**OFFICE OF THE STATE ENGINEER**  
**DIVISION OF WATER RESOURCES**

We have reviewed the document submitted entitled, "Public Health Risk Assessment, 881 Hillside Area (OU1), Technical Memorandum No. 6, Exposure Scenarios, Revision 3.0", dated March 1992. The purpose of our review was to specifically evaluate the findings presented in Appendix B, "Investigation and Simulation of Water Production Capabilities".

OU1 881 Hillside

**Technical Arguments to Exclude  
Groundwater Ingestion from the BRA**

### FLOW CHART FOR FATE AND TRANSPORT ASSESSMENTS

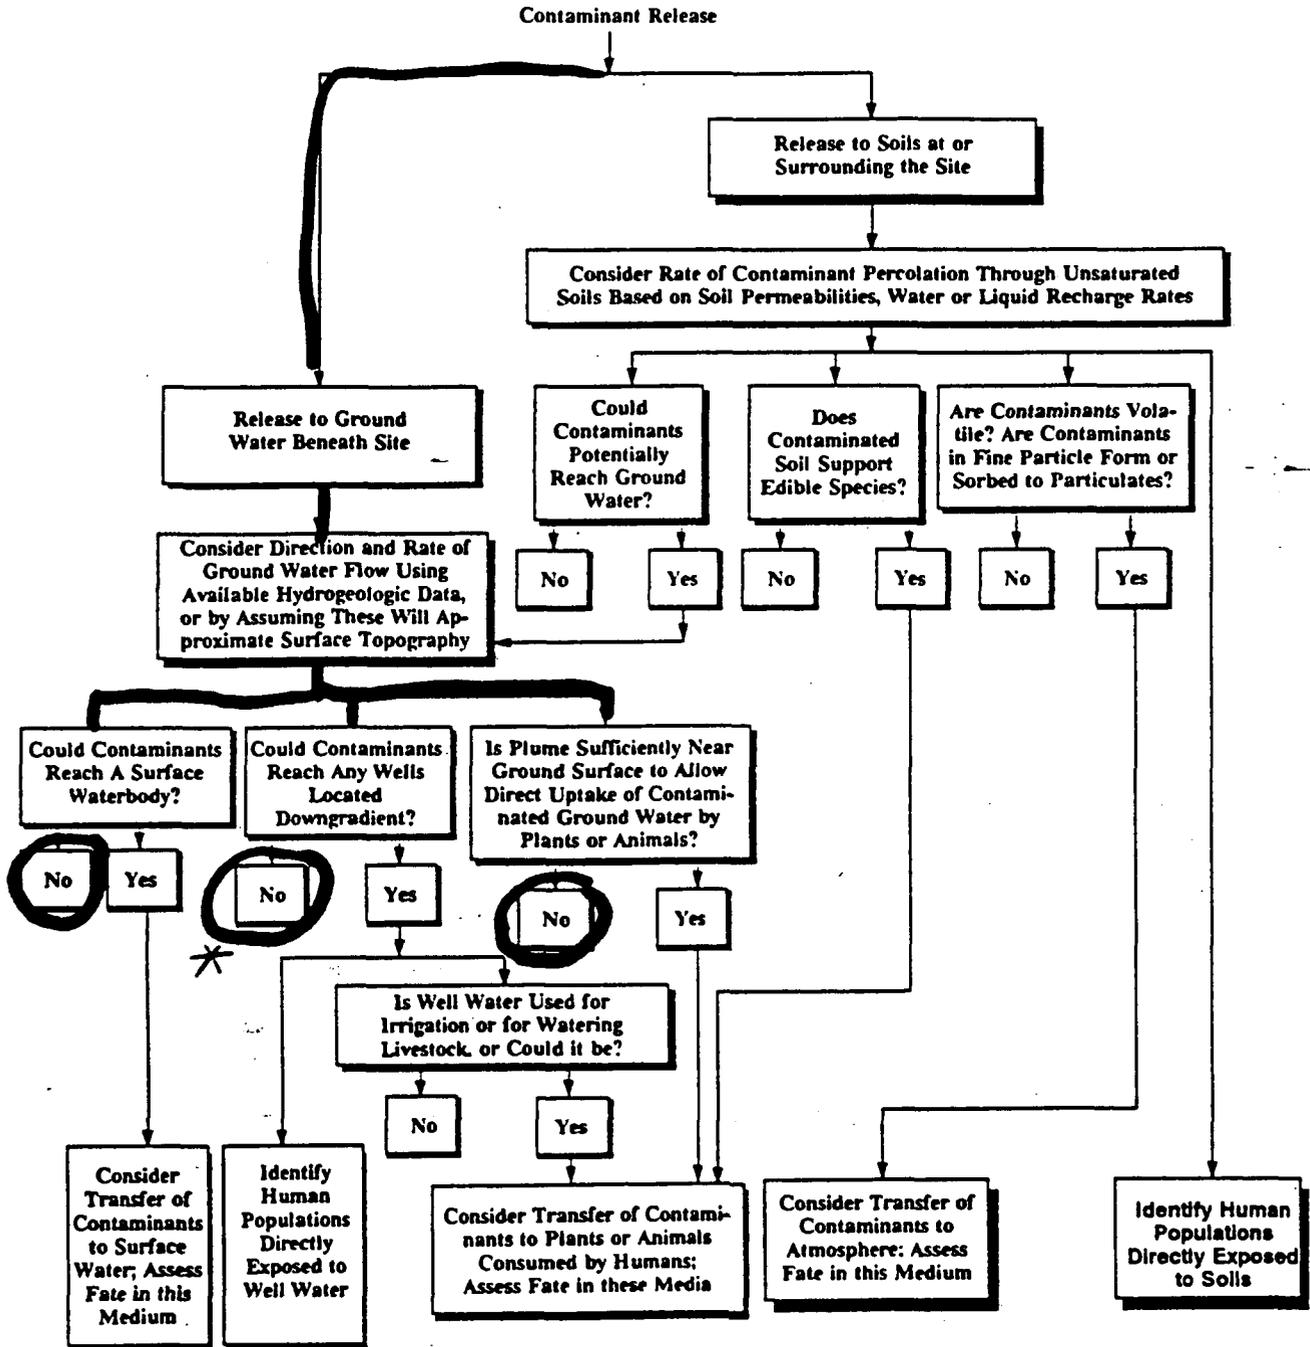
1) Followed EPA methodology (conservative) (attached Figure)
